Service Campaign Bulletin

Campaign No. 2019080019, November 2019

SUBJECT: **Various Models**
Model Years 2012-2017

Replace Steering Gear Bolts

Figure 1

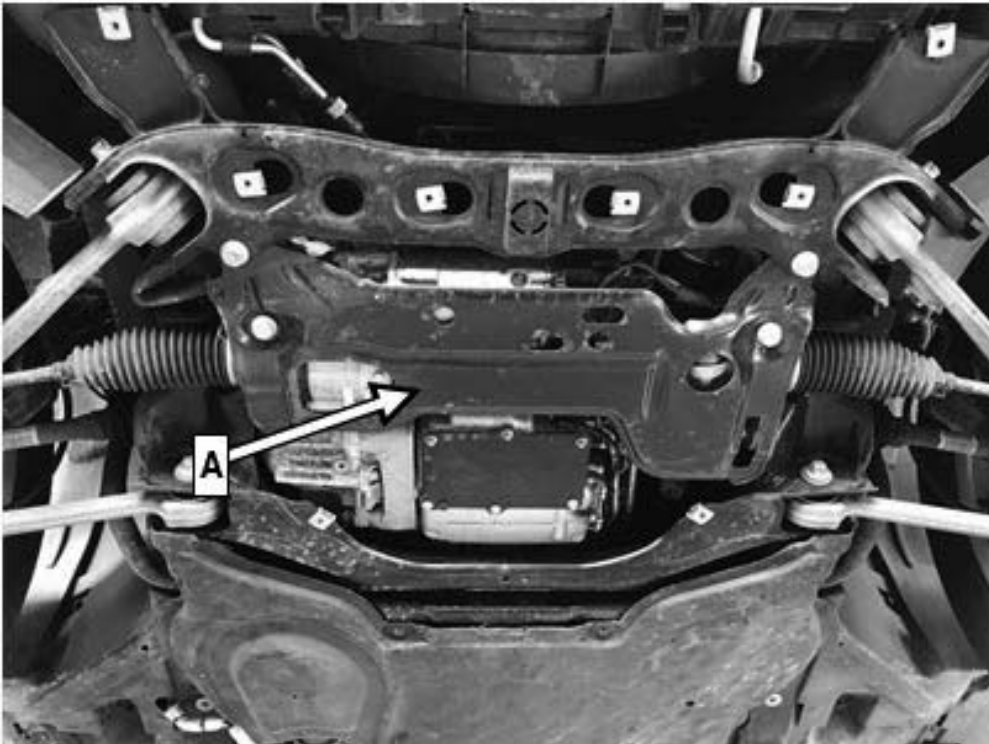
2. Remove mounting plate (A, Figure 1) for steering gear.

Figure 2

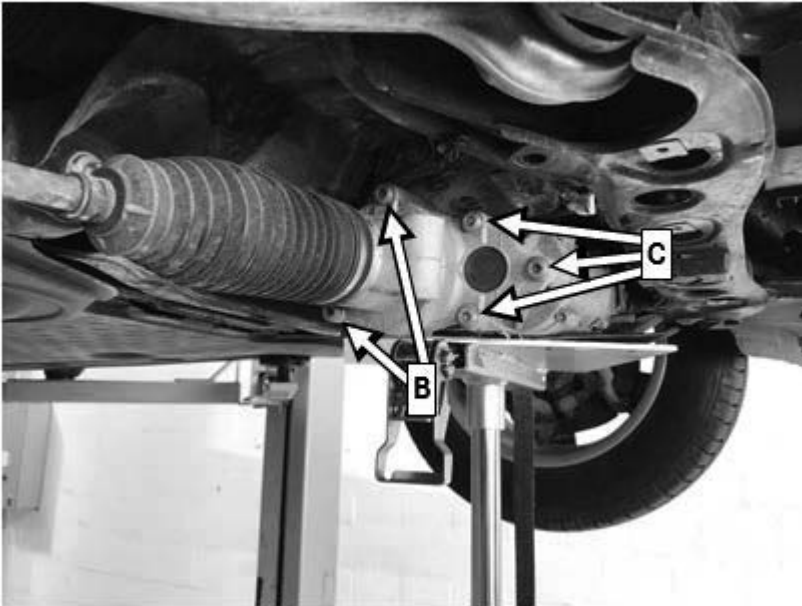
4. Remove screws (B and C, Figure 2), making **absolutely sure** to do so **individually and one after the other**, replace with new steel screws and tighten with the specified torque incl. tightening angle.

- i** The procedure must be completed so that the power-pack does not twist away from its set position thus resulting in consequential damage.
 - Nm** Power-pack screw on steering gear: **5 Nm and 90°** tightening angle.

- i** If a **screw** should **break off** or have already broken off, **replace the electric power steering rack.**
 - i** For basic data, **see AR46.20-P-0600EL and AR46.20-P-0600EF.**

Figure 3

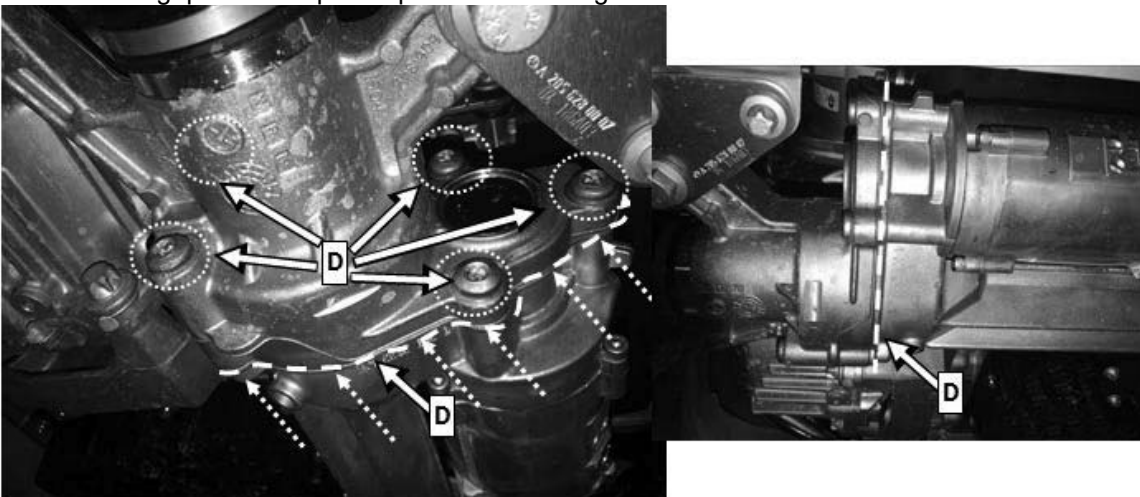
5. After replacing the screws, apply a generous coat of wax to the area (**D, Figure 3**) around the screw heads, screw ends, and the gap between the power-pack and the steering.

- i** Wax gap between power-pack and steering **all-round.**

Figure 5

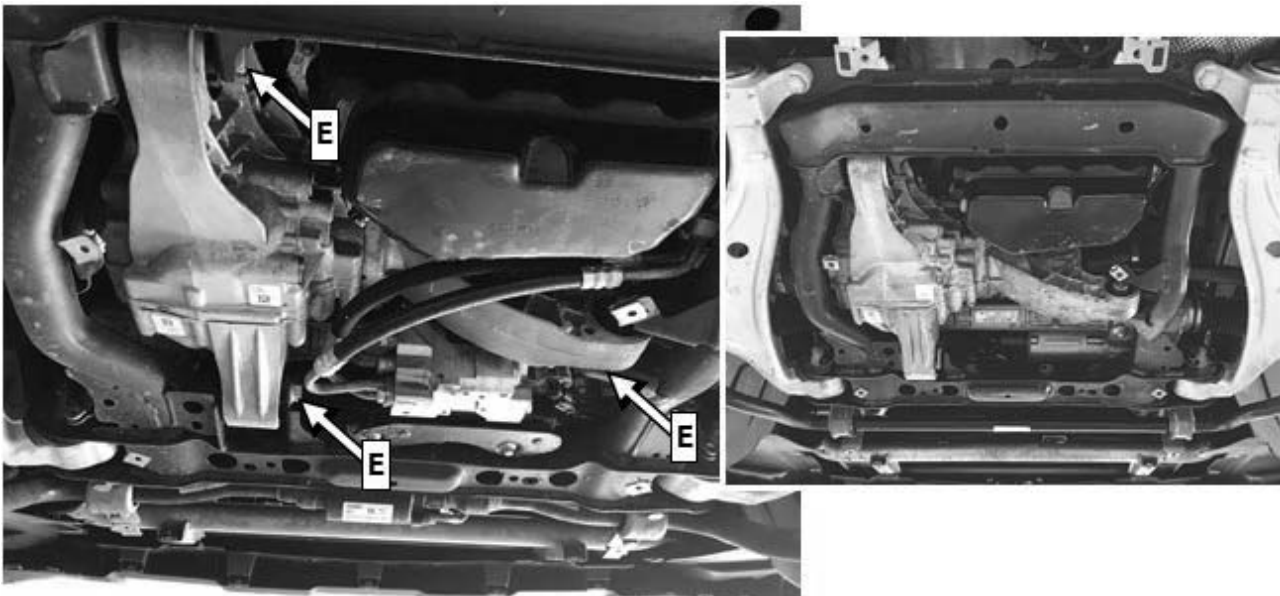
1. Remove center section of lower engine compartment lining.
2. Remove screws (E, Figure 5) connecting the front axle differential to the front axle carrier.
 - i** Front axle differential remains lying in front axle carrier. It is only slightly lowered.
 - i** **No further** threaded connections are released at front axle differential.
 - i** For basic data, see **AR33.30-P-0525GQ**

Figure 6

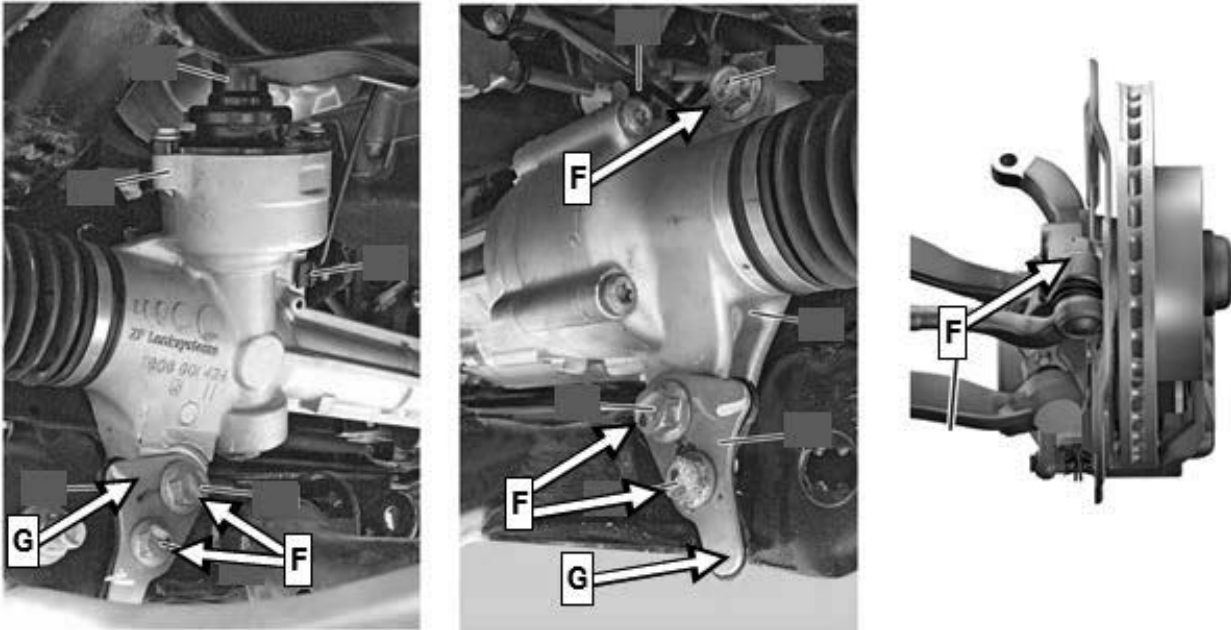
3. Unscrew steering from front axle carrier and tie rods at the steering knuckles (**F**, **Figure 6**).

- i** Steering coupling to steering column is **NOT** released.
- i** For basic data, see **AR46.20-P-0600GQ** and **AR46.40-P-0200EW**
- i** Additional threaded connections do not have to be released.
- i** Remove retaining plates (**G**, **Figure 6**).

Figure 7

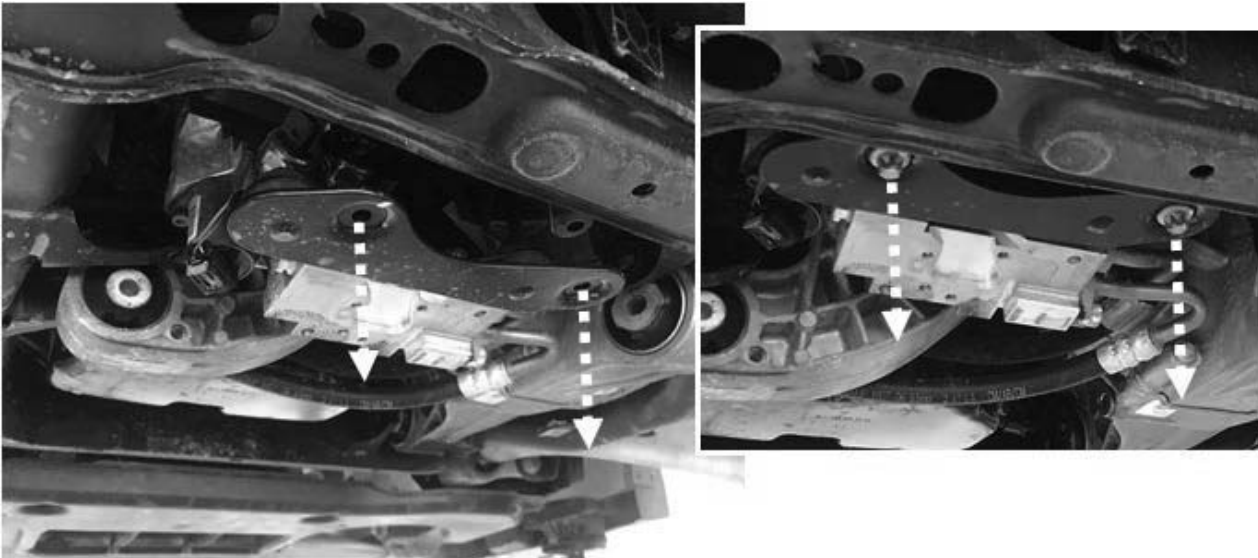
4. For vehicles **with code 468 (Active Curve System)**, unscrew the hydraulics block (**Figure 7**) and slightly press downwards with lines connected.

Figure 8

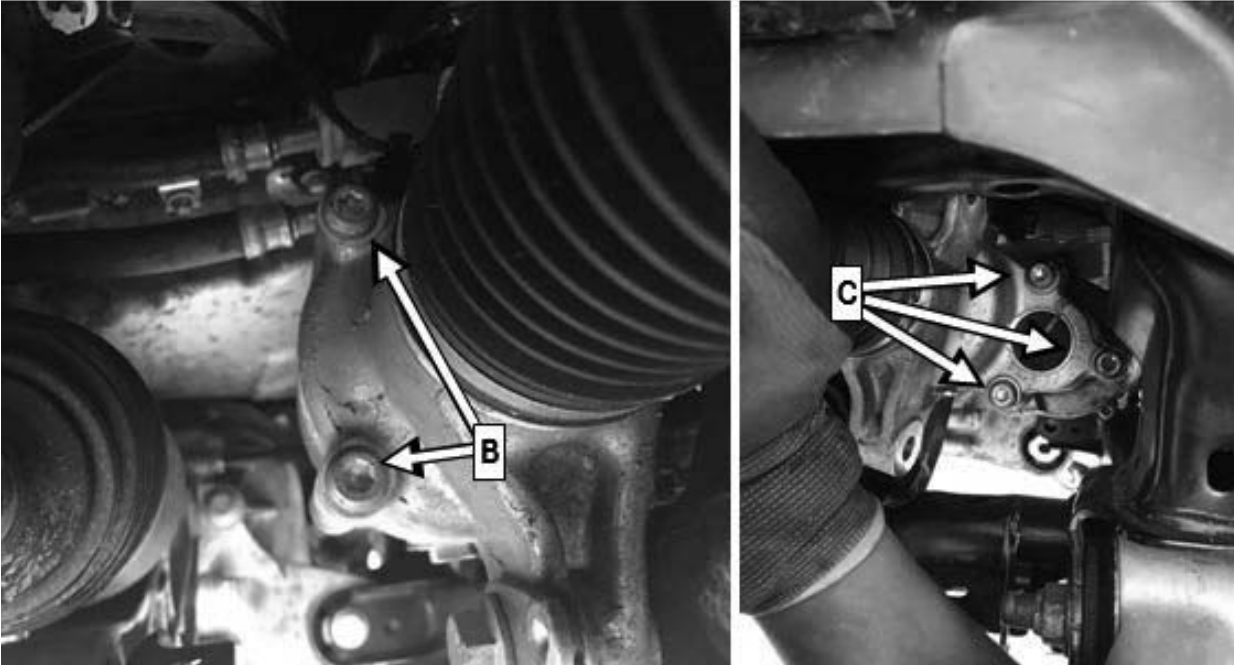
5. Slightly lift steering on left and right and move towards rear in front axle carrier so that the screws (**B and C**, **Figure 8**) are accessible.

6. Remove screws (**B and C, Figure 8**), making **absolutely sure** to do so **individually and one after the other**, replace with new steel screws and tighten with the specified torque incl. tightening angle.

- i** The procedure must be complied with so that the power-pack does not twist away from its set position thus resulting in consequential damage.
- i** **Important:** Take into account the different screw lengths of screws B and C in models 166 and 292!

- Nm** Power-pack screw on steering gear: **5 Nm and 90°** tightening angle.
- i** If a **screw** should **break off** or have already broken off, **replace the electric steering rack**.

Figure 9

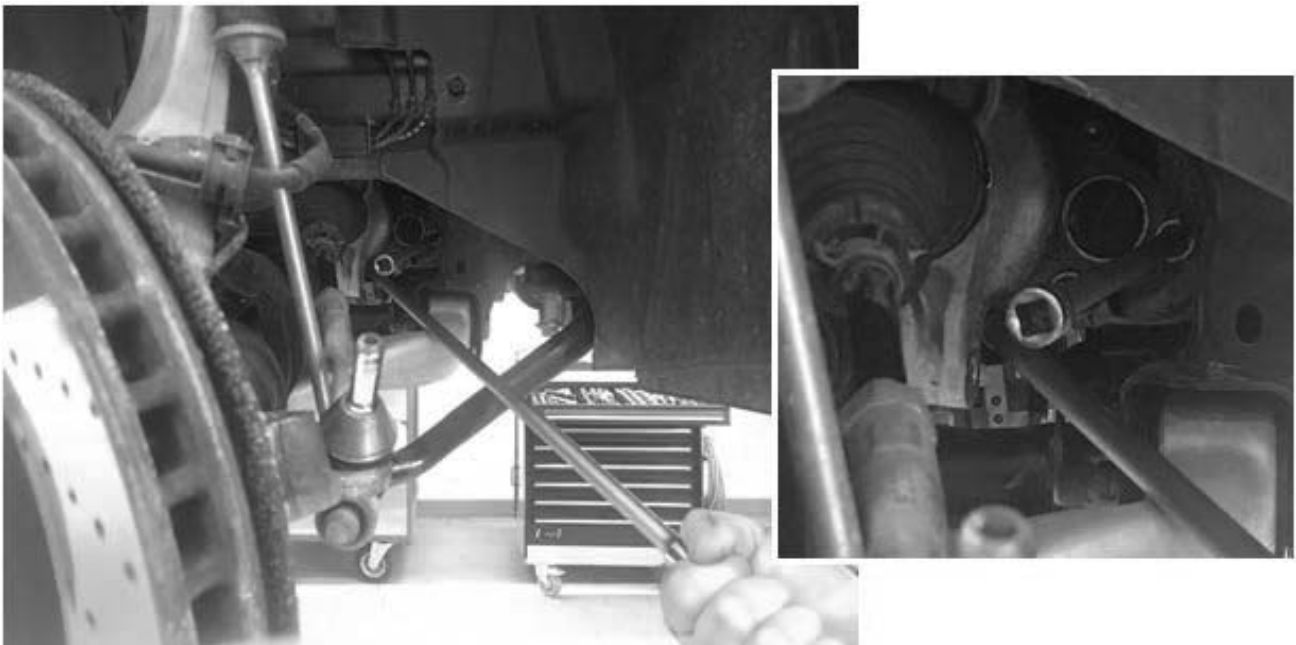
i Keep the steering pressed towards the rear with the aid of a helper as shown (**Figure 9**).
